MASTER LIFT STATION 12A IMPROVEMENTS MANATEE COUNTY, FL.

PROJECT NO. 0019706-5001200

As-Builts

LEGEND / NOTES & SITE PLAN
MANATEE COUNTY LIFT STATION - 12A SANITARY SEWERAGE PROJECT

SITE PLAN LIFT STATION 12A
SCALE: 1"=20'

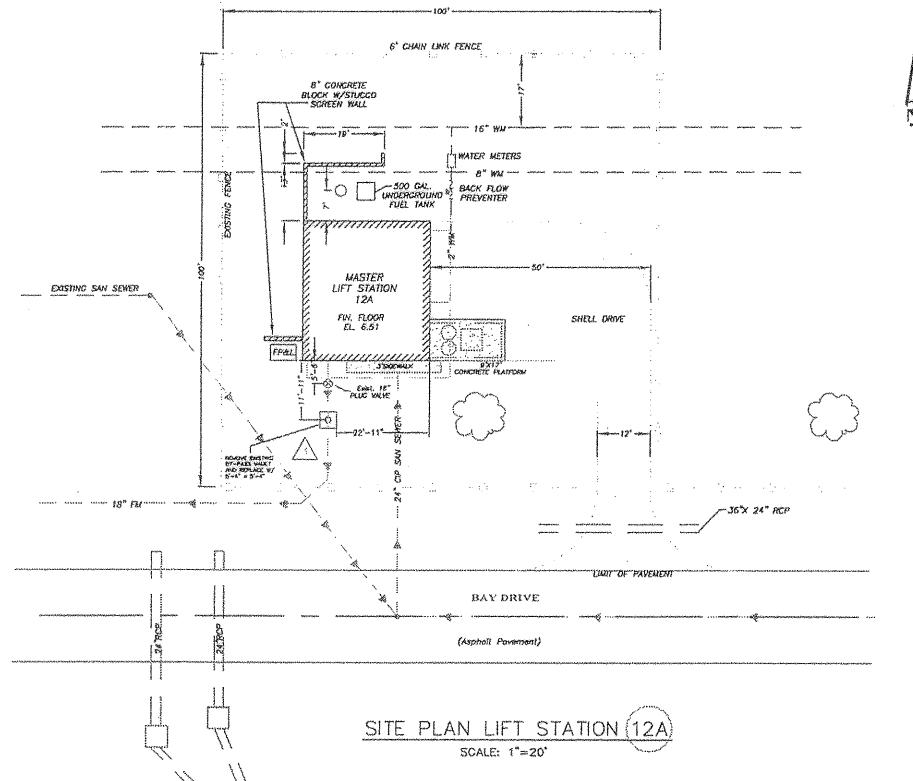
- By-pass Connections-Lift Station 12A & 27A**
The 8" by-pass connections do indeed constitute serious flow restrictions. Our suggestions was and is to consider using the lift stations' pumps as much as possible.

- By-pass Valve Arrangements-Lift Stations 12A & 27A**
There is an 8" valve located at each pump bypass connection as previously stated. I do not yet see any need for a line stop regarding bypass pumping.

- Existing 24" Plug Valve**
Nothing is to be done about the existing 24" plug valves upstream of the meter vault locations unless, as previously mentioned, they do not function properly. Also, as previously mentioned, the so-called existing 24" plug valve shown on the drawings does not, in fact, exist.

- Fitting/Valve Replacement-Bypass Assemblies**
There is no requirement at present to replace anything related to the bypass connections.
- Pumping Capacities-Wet Well Drawdown Pump Valve Replacement**
The blanket statement that the station pumps could not keep up with the incoming sewage flows is not true. I suggest that any bidder or the Contractor can contact Jim Marble to work out best days and times for executing plug valve replacements both on the pump suction and pump discharges.

2.0) **Pump Operation Data - STA's 27A and 12A**
The Contractor should use the design pump data as a base for calculating the requirements for bypass pumping. That is, STA 12A-3200, GPM @ 112 ft. TDH and STA 27A-4200 GPM @ 51 ft. TDH.

Further, Jim Marble advises that if groundwater is high and/or there is continual significant rainfall, one should double the bypass pump base capacities.

BYPASS/FLOW METER VAULT DETAIL
SCALE: 3/8"=1'-0"

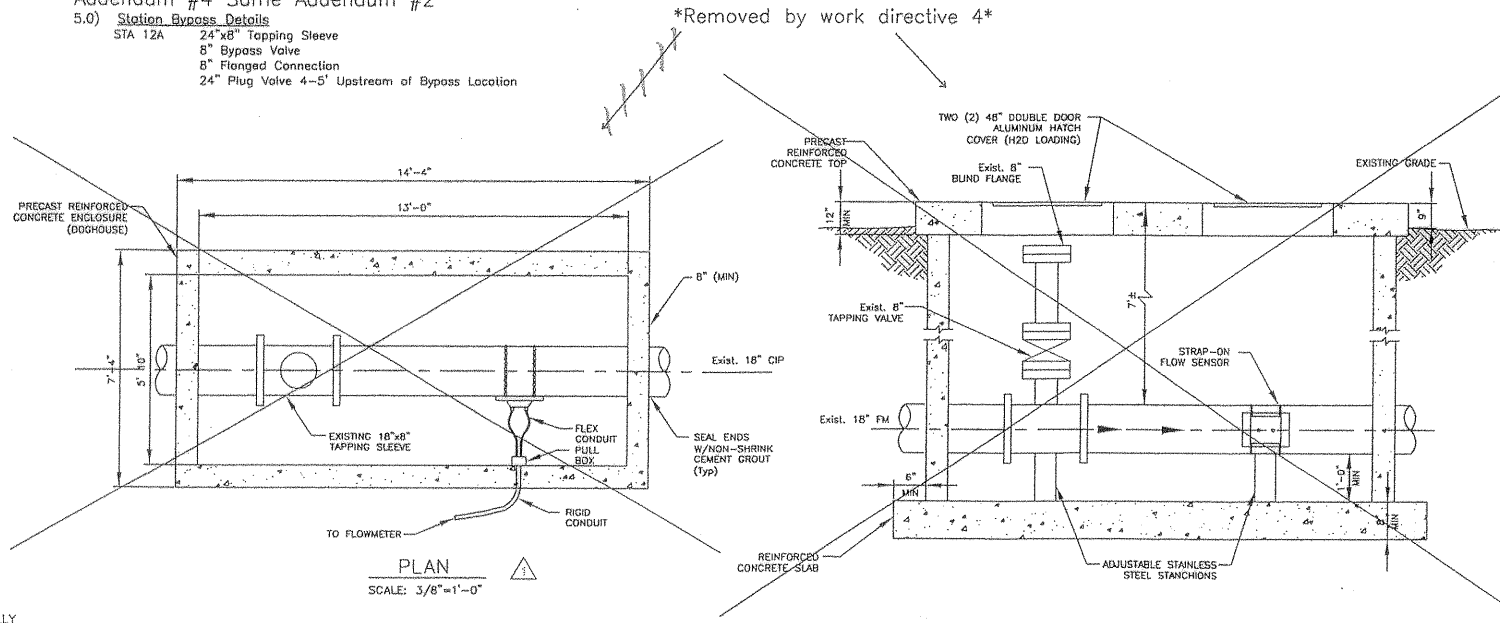
1.0) **Steel Reinforcement-CMU Walls-Valve/Meter Vaults**
The steel box reinforcement should be vertical bent bars tied to the reinforcing steel bars in the bottom slab. Bent bars should be placed in every other block cell around the perimeter of the vault. Those cells would then be filled with concrete. In this design case or for any other alternate design, the Contractor will have to provide shop drawings for approval by the Engineer.

5.0) **Station Bypass Details**
STA 12A 24"x8" Tapping Sleeve
8" Bypass Valve
8" Flanged Connection
24" Plug Valve 4'-5" Upstream of Bypass Location

FLOOR PLAN - PUMP ROOM & WET WELL
DEMO PLAN SCALE: 1/4" = 1'-0"

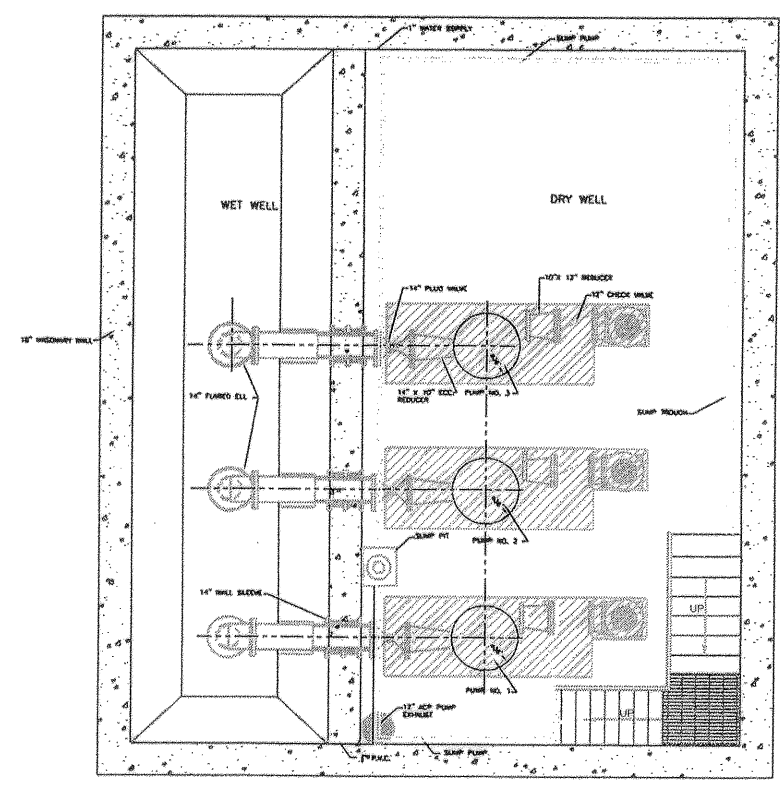
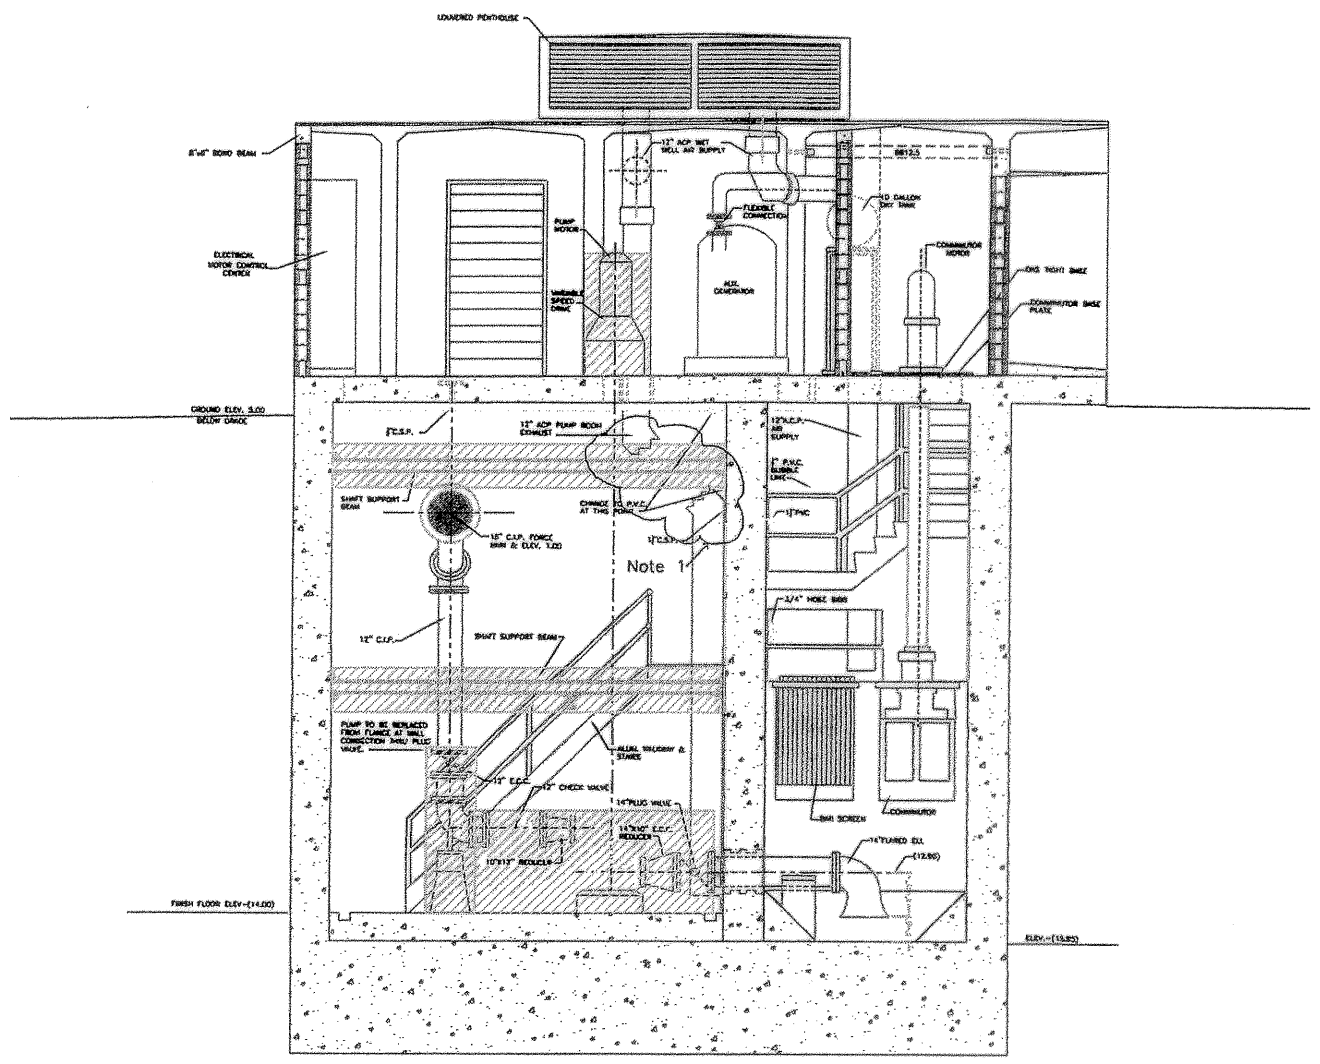
Note 1:
Removed by
Field Directive 2

MASTER LIFT STATION 12A SECTION
PROPOSED SCALE: 3/8" = 1'-0"

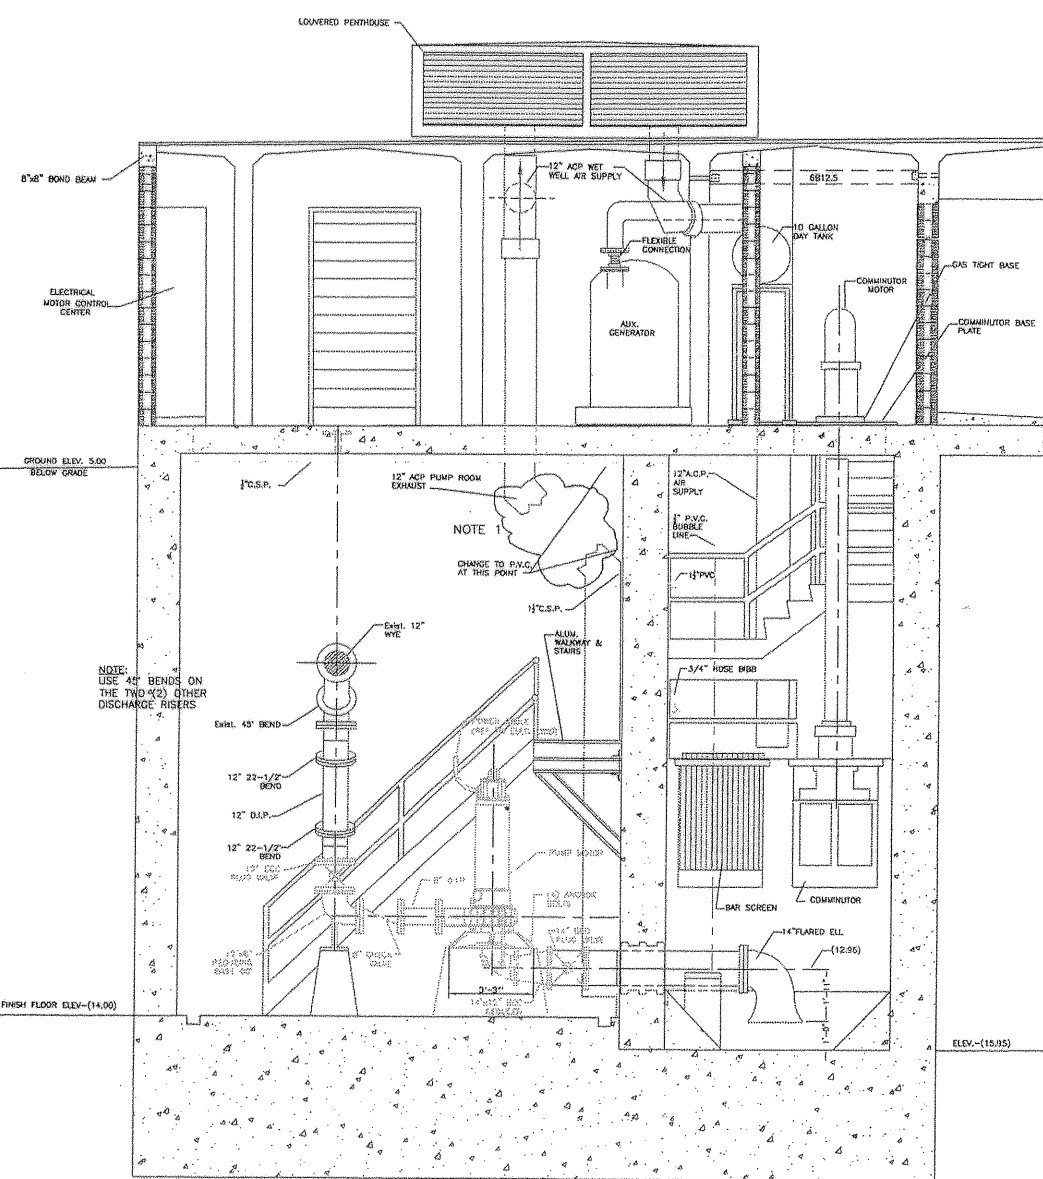
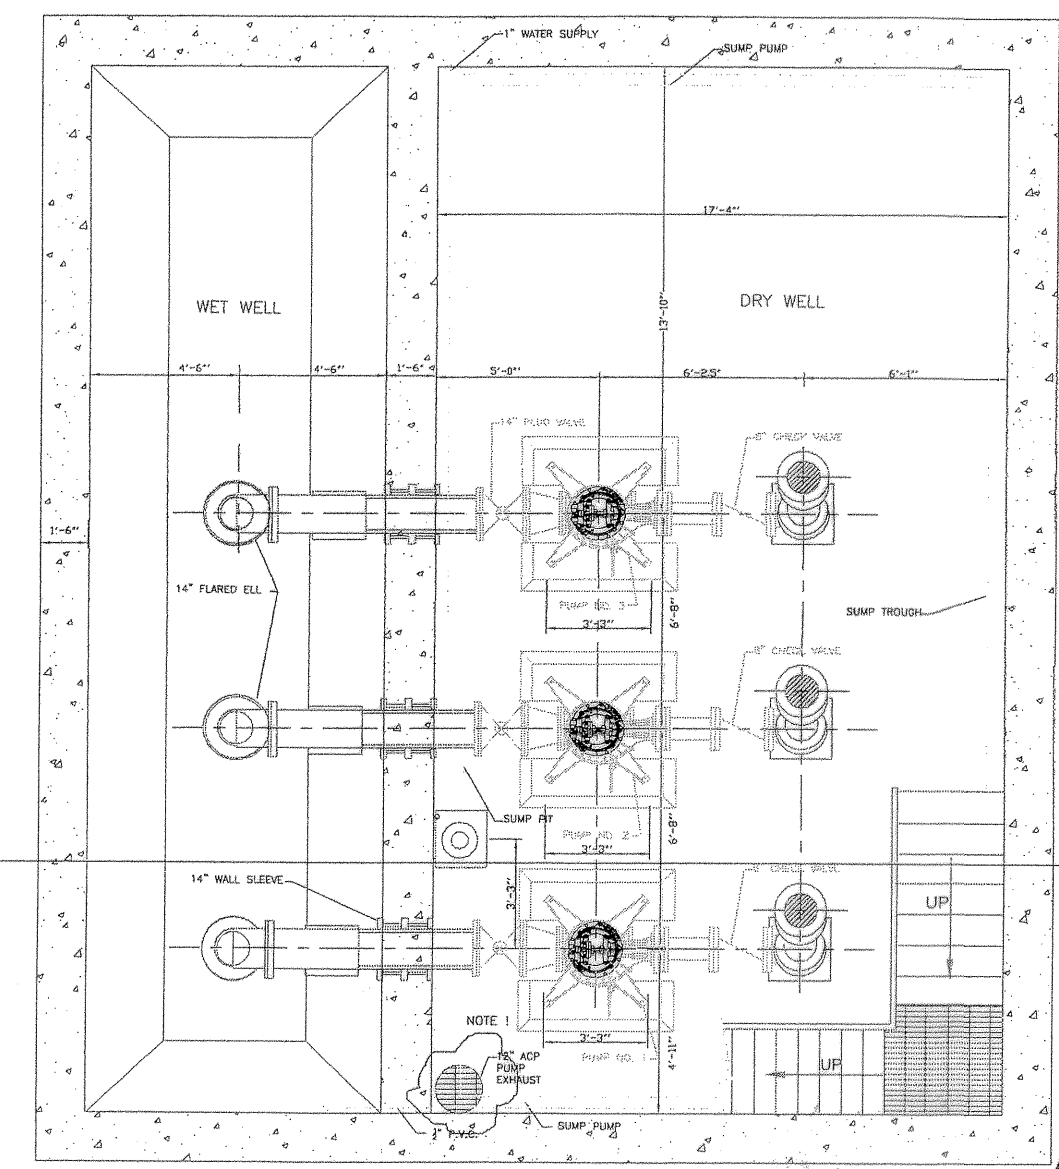
Note 1:
Removed by
Field Directive 2

SECTION 1A
SCALE: 3/8"=1'-0"

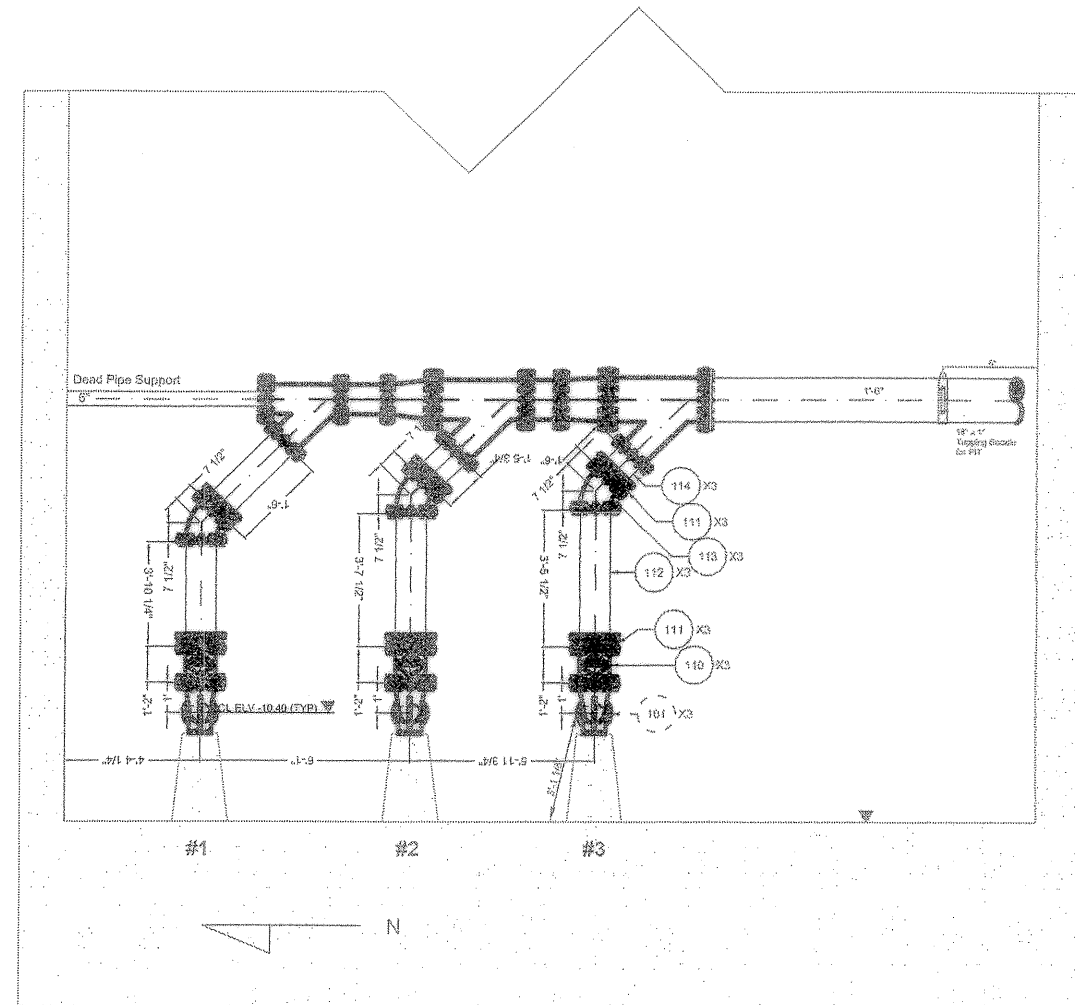
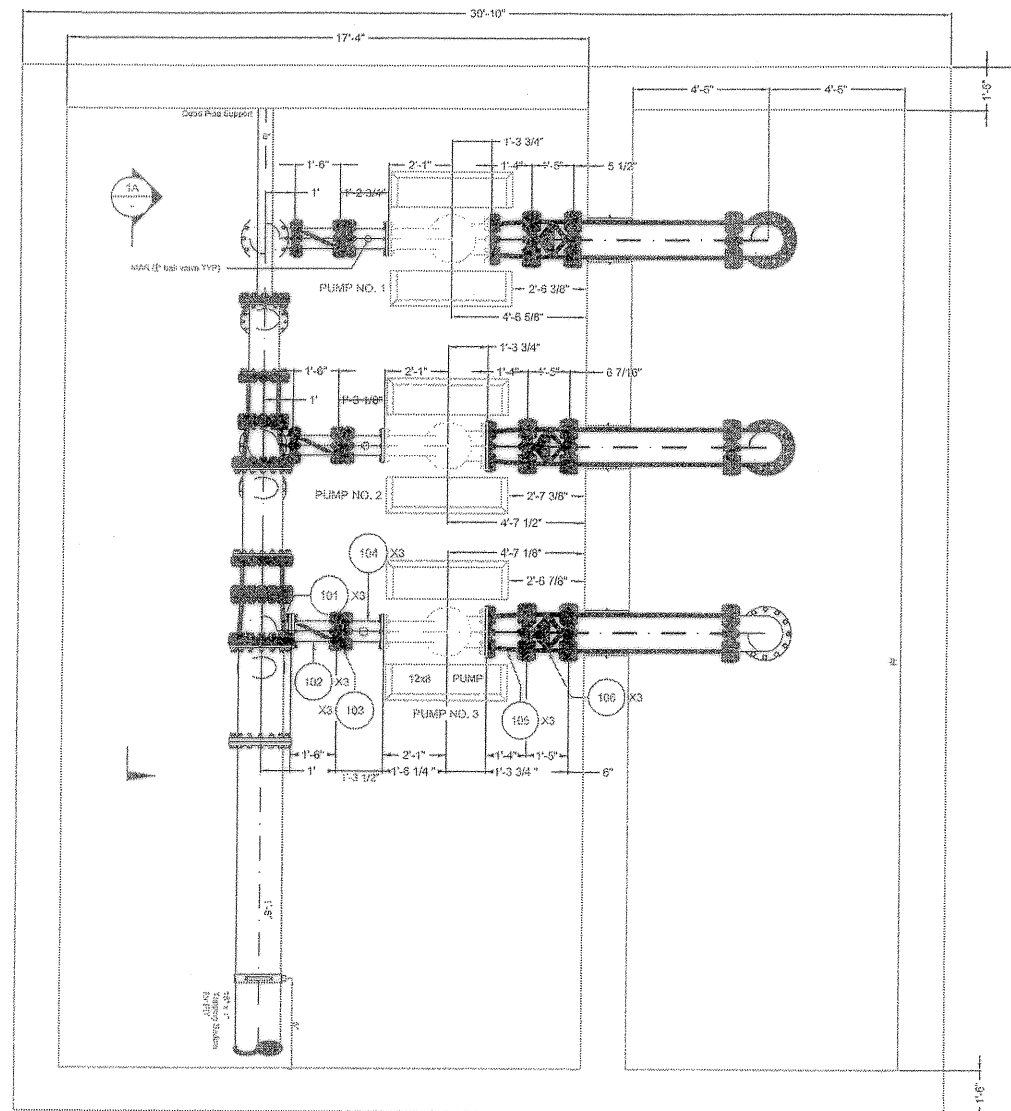
3.0) Pump and Pump Fittings Dimensions
The Contractor should use manufacturer's pump and fitting dimensions shown.

PLAN

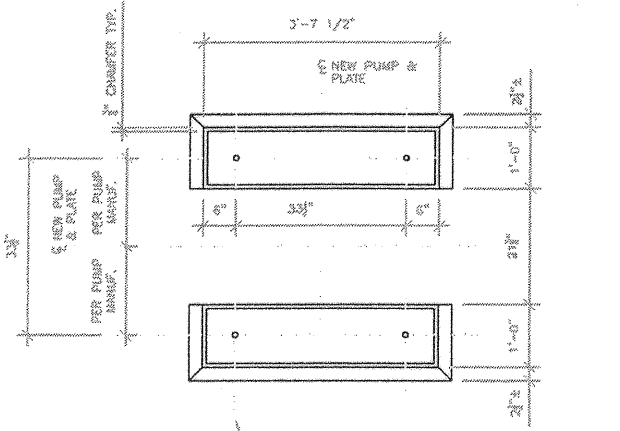
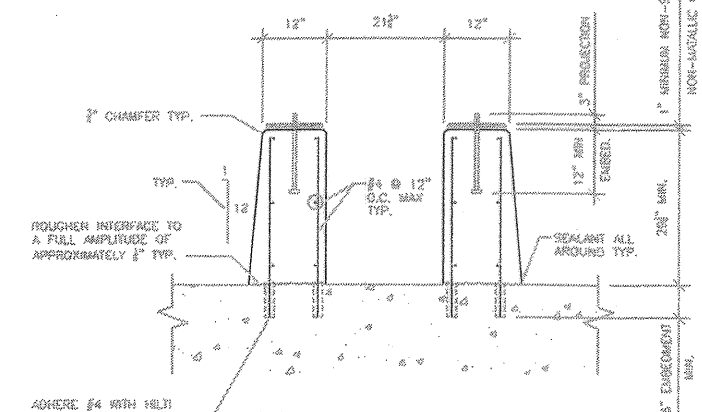
Removed by work directive 2.
